Technical Service Information

CHRYSLER A500/518 OVERDRIVE SUN GEAR

Figure 1

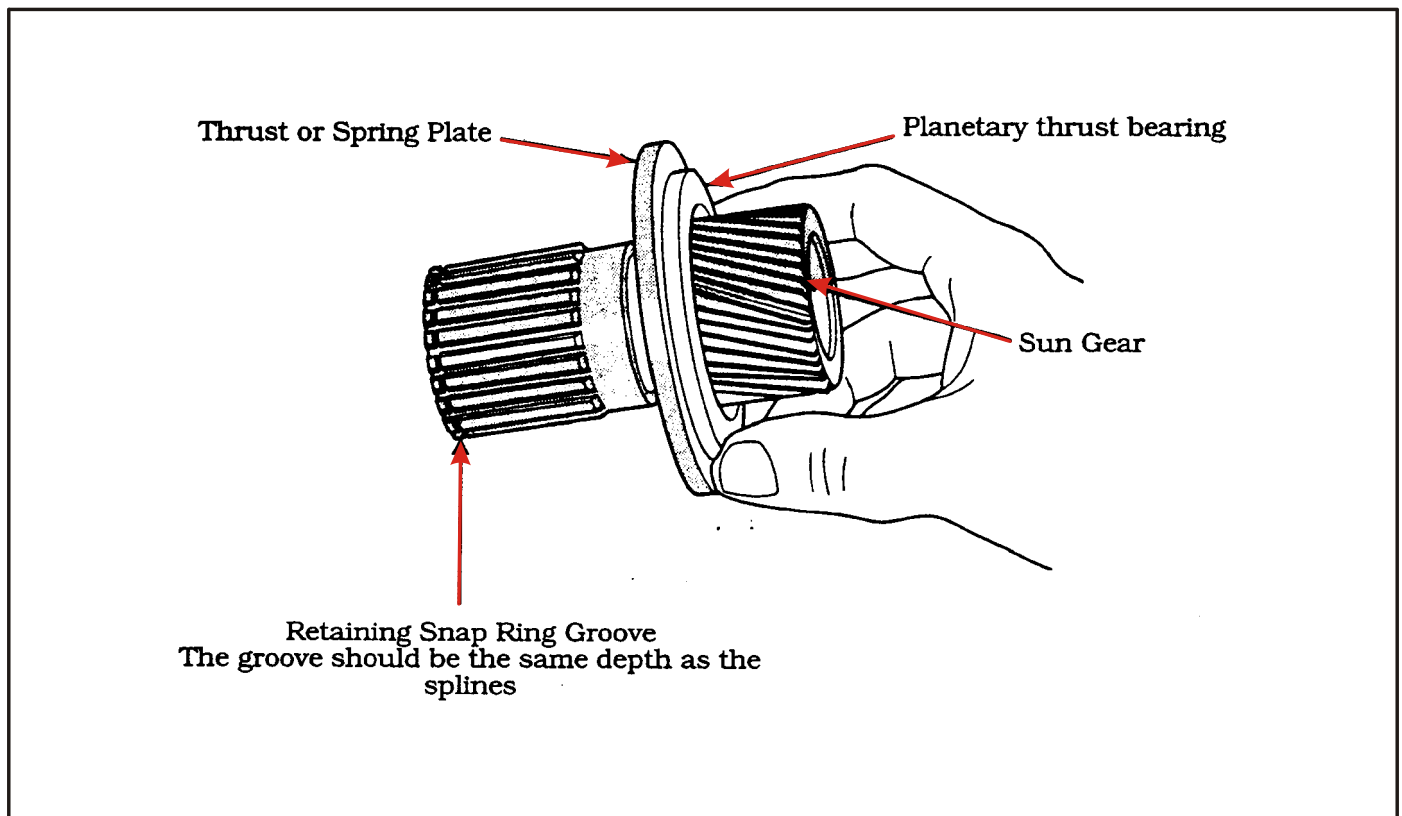
- COMPLAINT:** The retaining ring snap ring groove in a newly purchased sun gear does not seem to retain the retaining ring properly.
- CAUSE:** The retaining ring snap ring groove is not machined deep enough to accommodate the snap ring.
- CORRECTION:** The snap ring groove should be machined the same depth as the splines. You can machine the groove down all the way yourself or reorder a new sungear.
